Wet Bay Door "C" Hinge, Revision 2

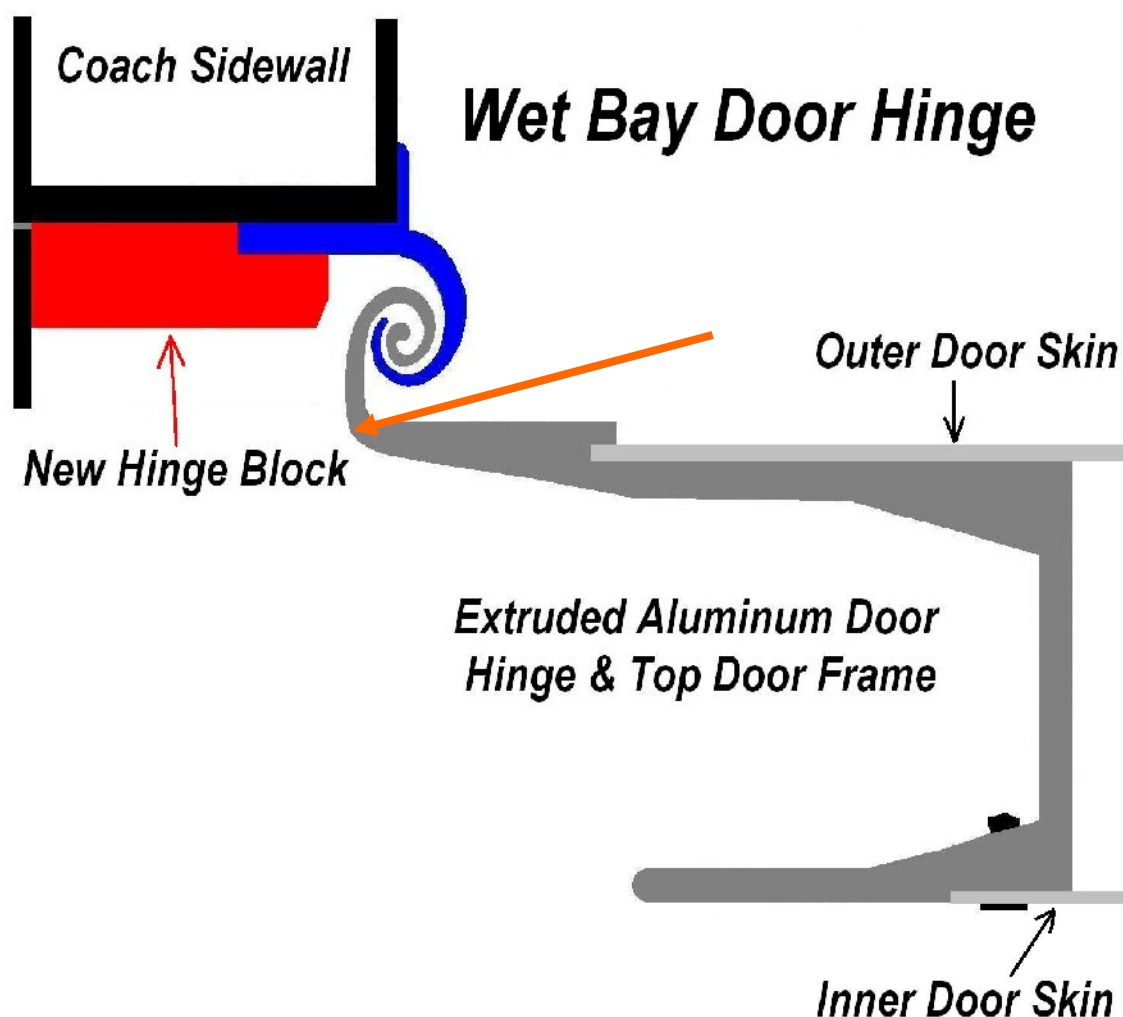
Looking at the orange arrow you can see where the bind will come into play as the door is closed, the channel will rotate and come in contact with the new door blocks without adequate clearance. Looking at the Wet Bay Door hinge you can see it is not rounded like the letter "C" but more rounded like the side of an egg.
